Attn: Secretary re WestConnex M4-M5 Link EIS, project number SSI 16_7485

I write to express my strong objection to the WestConnex M4-M5 Link tollroad proposal.

Figure 6-4 Project footprints - Map 2

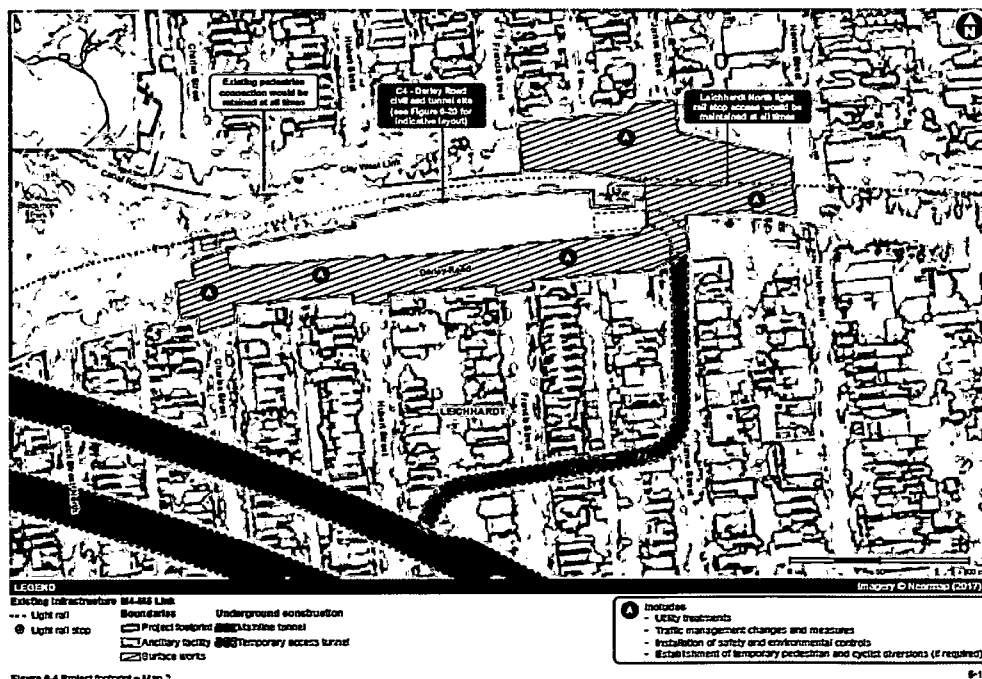
- I object to the EIS because it does not guarantee that the existing access to the Leichhardt North light rail stop would be maintained at all times. Fig 6-4 indicates that only the eastern access will be maintained. This greatly disadvantages the elderly and disabled who have to walk up a steep hill to the eastern access. If the proponent cannot guarantee access to the Leichhardt North light rail stop from the existing entry points or from points that are accessible to all then the Darley Road, Leichhardt construction site should be abandoned. The proponent should be directed to find a site where its operations will not impact on users of the Light Rail.
